**Nuclear Energy Institute  
International Event Scale Meeting  
June 25, 2003**

## II. Fuel Damage Classification Concerns

## **Fuel Damage Qualitative Criteria Recommendations**

PWR Typical Technical Specification Activity Example Curve

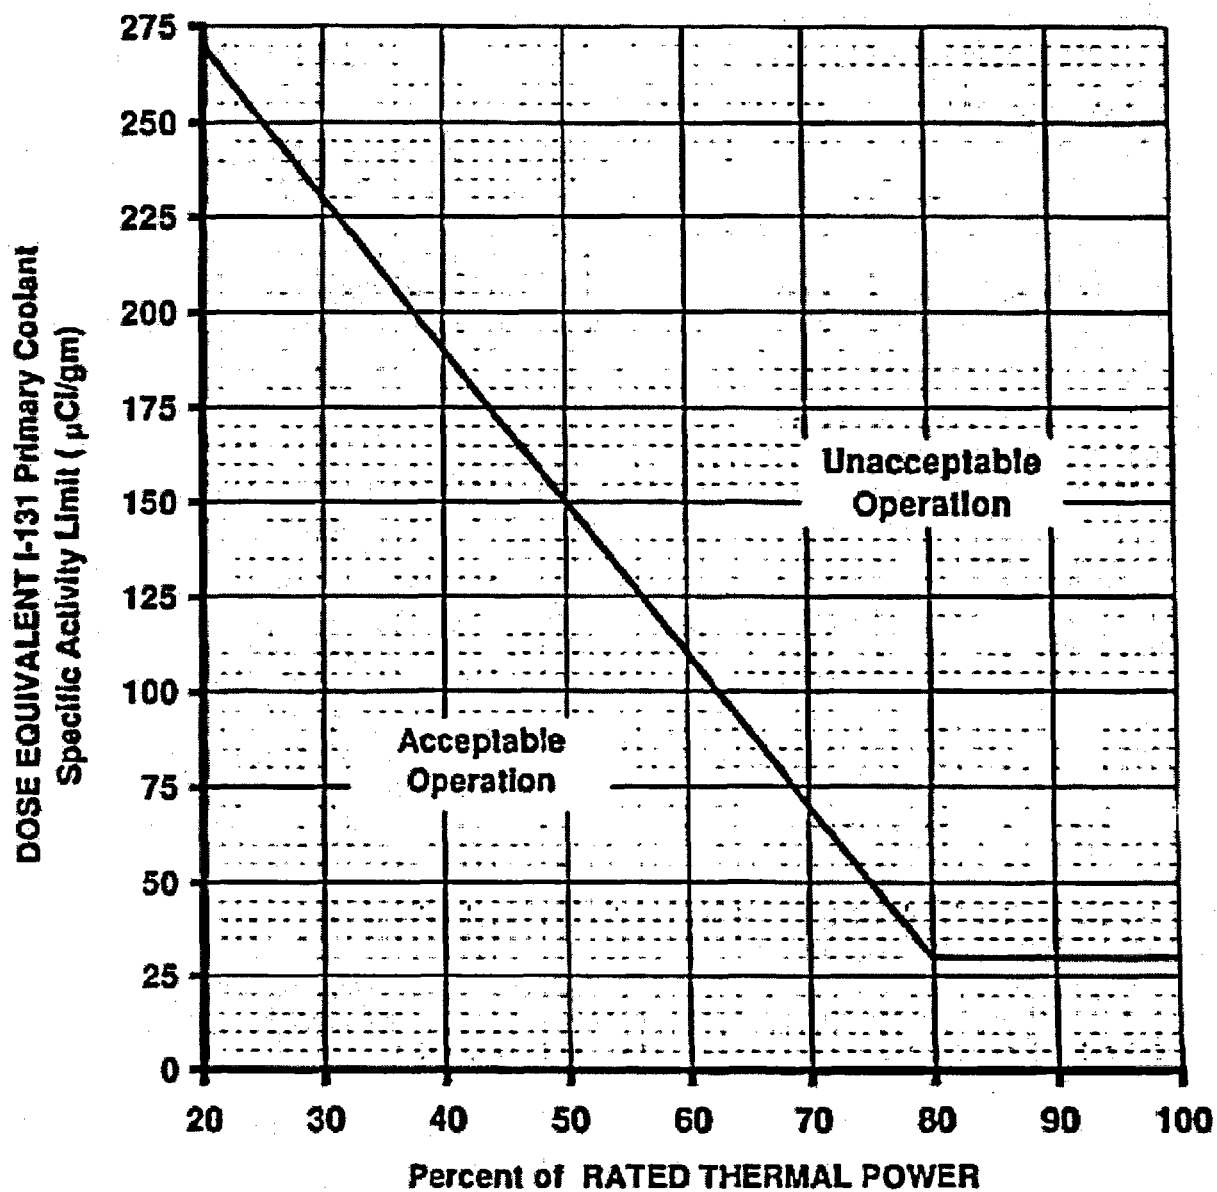
In most US industry events involving fuel clad damage over the last 20 years, RCS activity has remained within the Technical Specification LCO range with I-131 coolant activity remaining in the acceptable operating range of the Technical Specification activity limit curve (an example typical PWR curve is attached). Using a literal interpretation of the INES criteria these events could have been misinterpreted, especially for BWR events, and end up being over-classified using On-Site impact criteria instead of Defense-in-Depth impact criteria. The following supporting details assume that "barrier damage" or "core damage" is synonymous with "clad damage" (i.e., this is not an overheat/melt condition):

DEI elevated into the Unacceptable Operation region of the Technical Specification transient limit requiring shutdown.

DEI elevated into the Allowable Operation region of the Technical Specification transient limit for greater than the specified action statement time limit requiring shutdown.

DEI elevated out of normal Technical Specification operating limit but returned to within normal operating limit within specified action statement time limit with no shutdown required
